MAY 21, 2018

ADDENDUM NO. 2
TO THE CONTRACT DOCUMENTS

SYRACUSE HANCOCK INTERNATIONAL AIRPORT
REHABILITATION OF DEICING STORAGE FACILITIES

FAA AIP PROJECTS NO. 3-36-0114-XXX-18

G-101

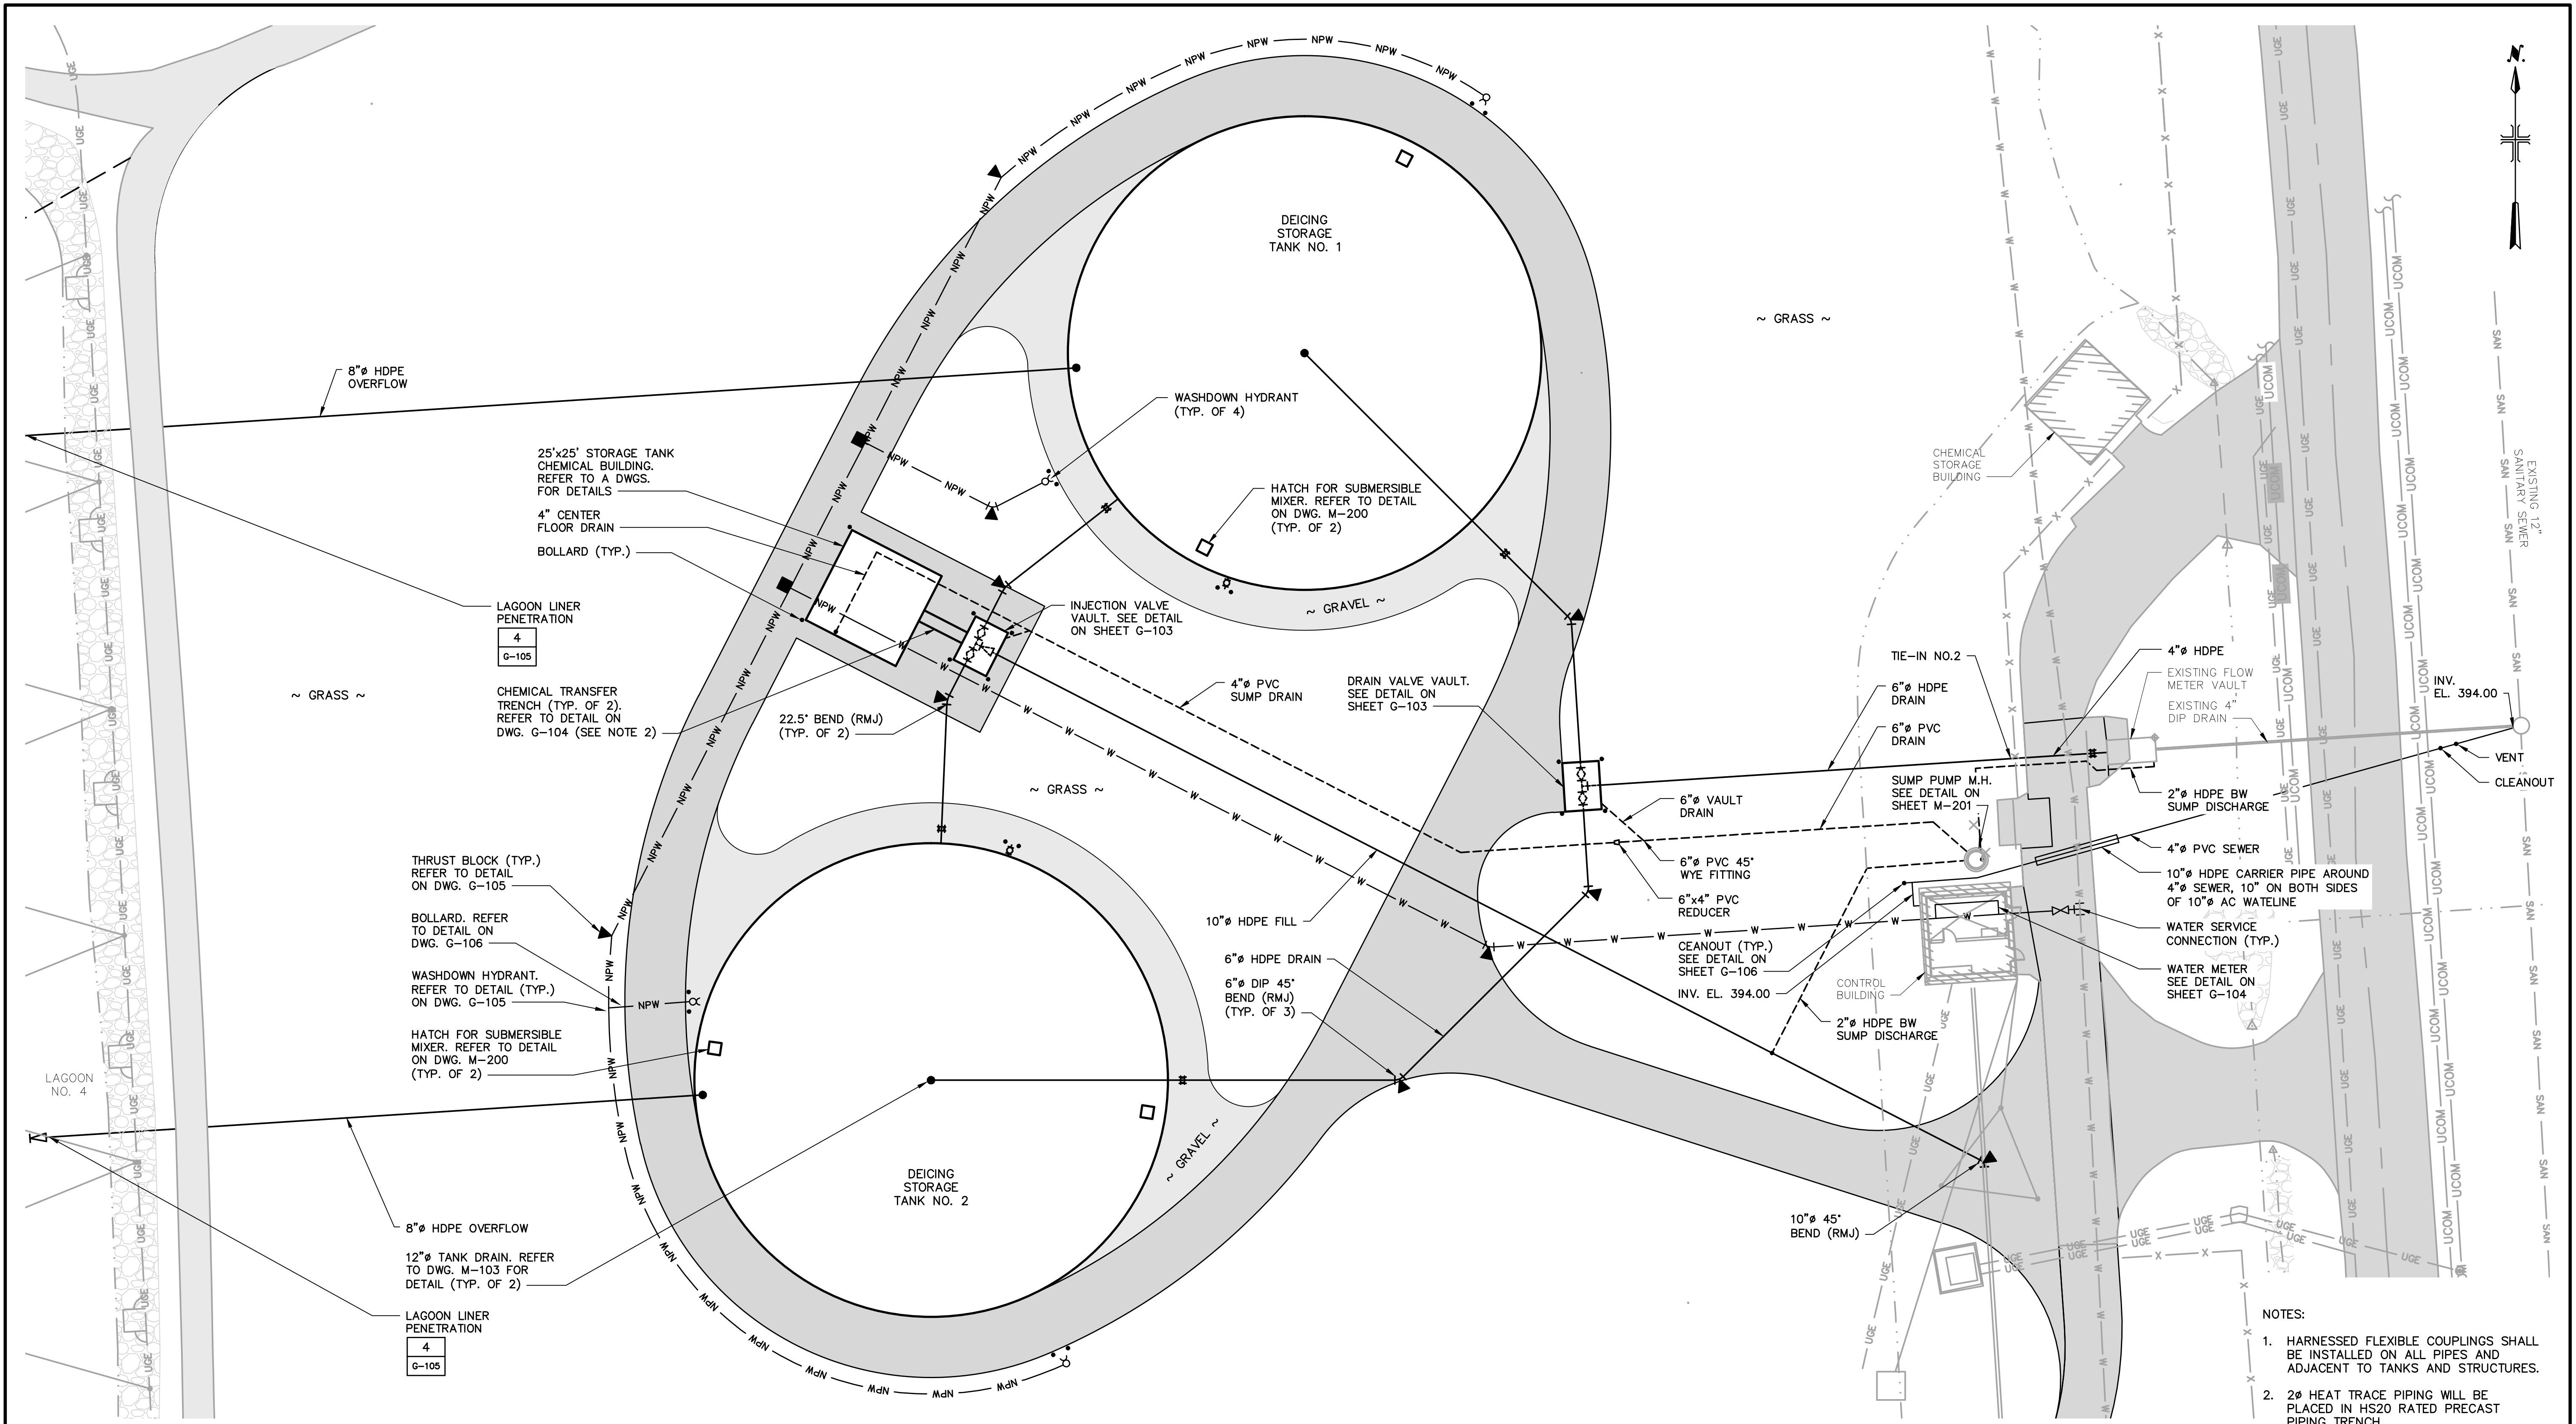
"2. THE FOLLOWING REPRESENTS ESTIMATES FOR EARTHWORK: TOTAL GENERAL FILL TO BE EXCAVATED IS +/- 11,500 CY. TOTAL GENERAL FILL TO BE PLACED AND COMPACTED IS +/- 10,000 CY. TOTAL EXCESS FILL IS +/-1,500 CY. CONTRACTOR SHALL MAKE HIS/HER OWN ESTIMATE OF EARTHWORK QTYS BASED ON THE CONTRACT DOCUMENTS"
2. Contract Drawing G-101:
 - a. Delete: Contract Drawing G-101 in its entirety

Insert: Attached Contract Drawing G-101
3. Contract Drawing G-102:
 - a. Delete: Contract Drawing G-102 in its entirety

1 PARTIAL SITE PLAN
 G-102
 1"=20'

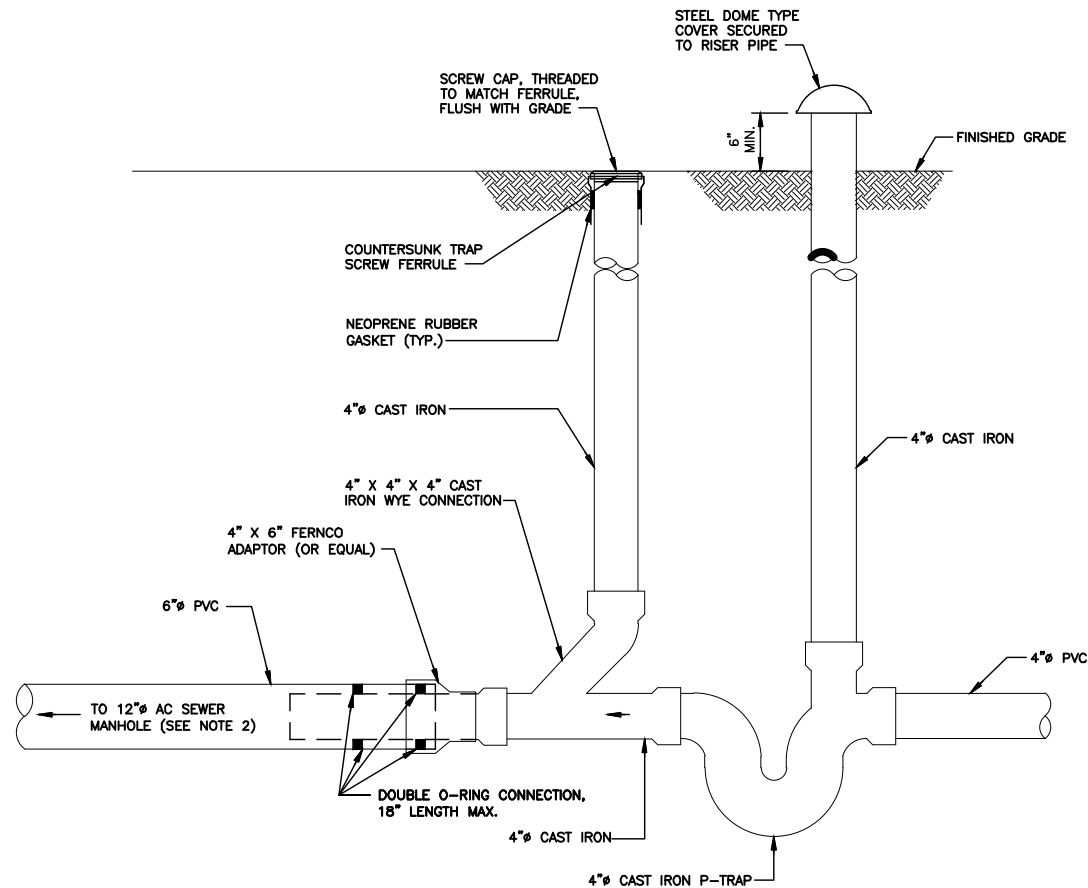
Insert: Attached Contract Drawing G-102
4. Contract Drawing G-106:
 - a. Insert: Attached Figure 1: "SEWER CLEANOUT AND VENT DETAIL"
